CITY OF DURBAN
 0539/12/90/4
 APPROVED: D. C. MACLEOD
 26 FEB 1991
 1991 MAR 18

INCORPORATING APPROVED PLAN No. 1042/07/87/6 APP. 14 JAN. 1998

Proposed alterations and additions to dwelling and amendments to approved plan no. 1042/07/87/6 at no. 4 The Drive for Mr. B. PASSMORE

Plan

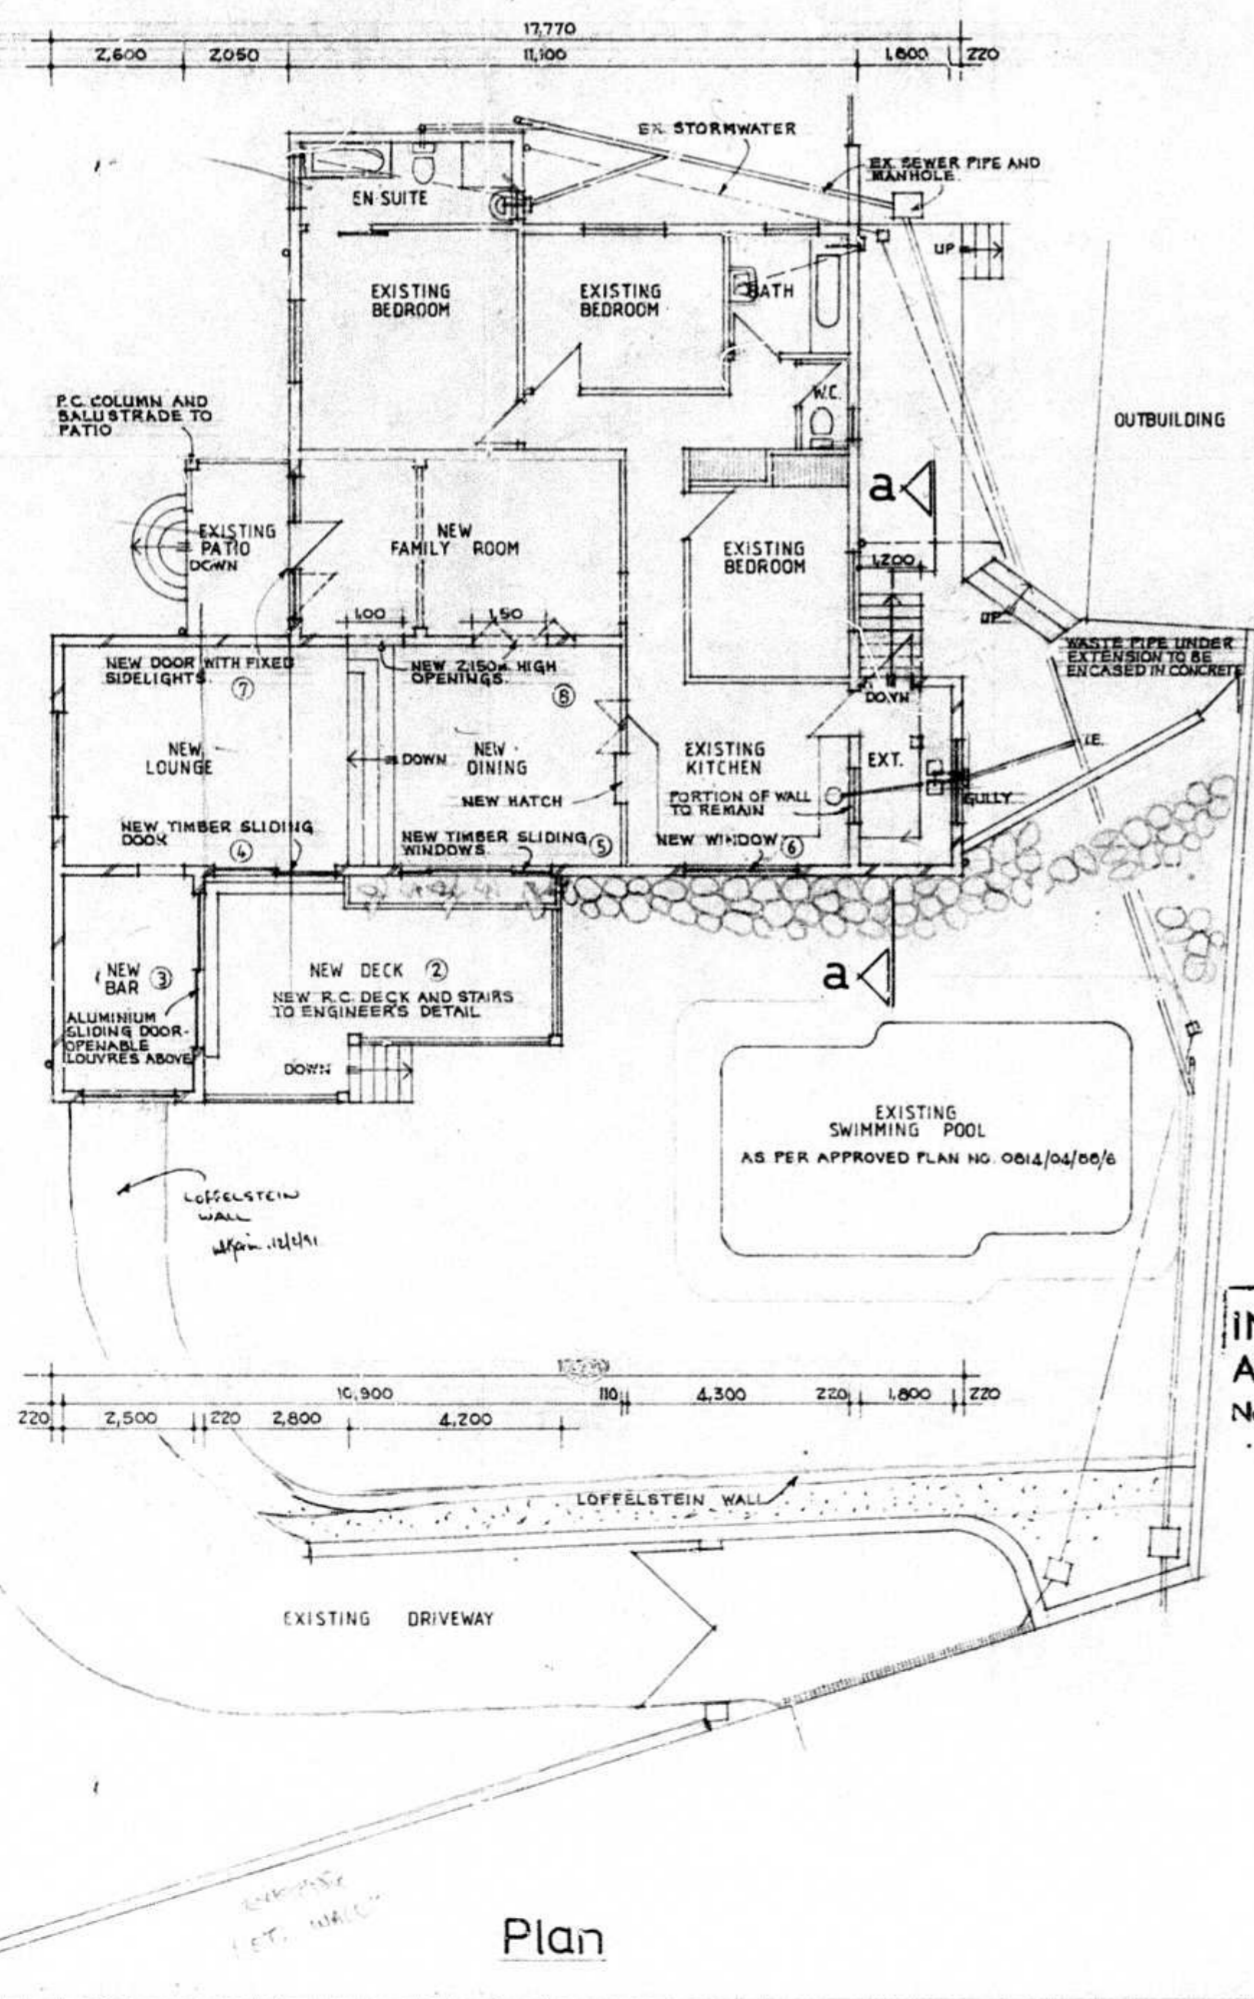
R/C DETAILS REQUIRED

ROOF STRUCTURE TO BE TO EMPIRICAL RULES OR DESIGNED BY ENGINEER
